PRODUCT CHANGE NOTICE

Part Marking Configuration Change for Intersil TDFN, uTDFN, and uTQFN Packaged Products

**Refer to:
PA10114**

Date: November 10, 2010

POD 1.2 x 1.0 - Single Digit Part Code

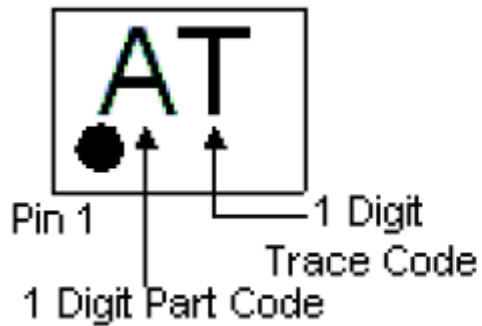
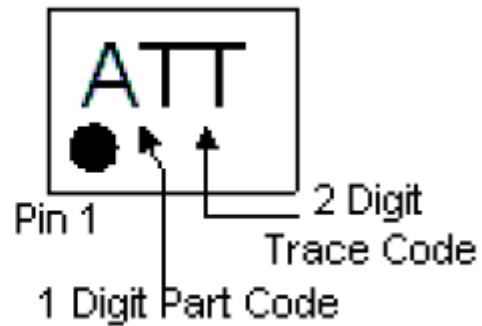
This notice is to inform you that Intersil is changing the configuration of the “top side” marking (brand) for the listed TDFN (Thin Dual Flat No-lead), uTDFN (Ultra Thin Dual Flat No-lead), and uTQFN (Ultra Thin Quad Flat No-lead) plastic packaged products. The restructured layout allows for the marking of additional characters in support of enhancing product traceability. There will be no change to the product code that is currently marked on the device. Examples of the current and new marking configurations are included for reference.
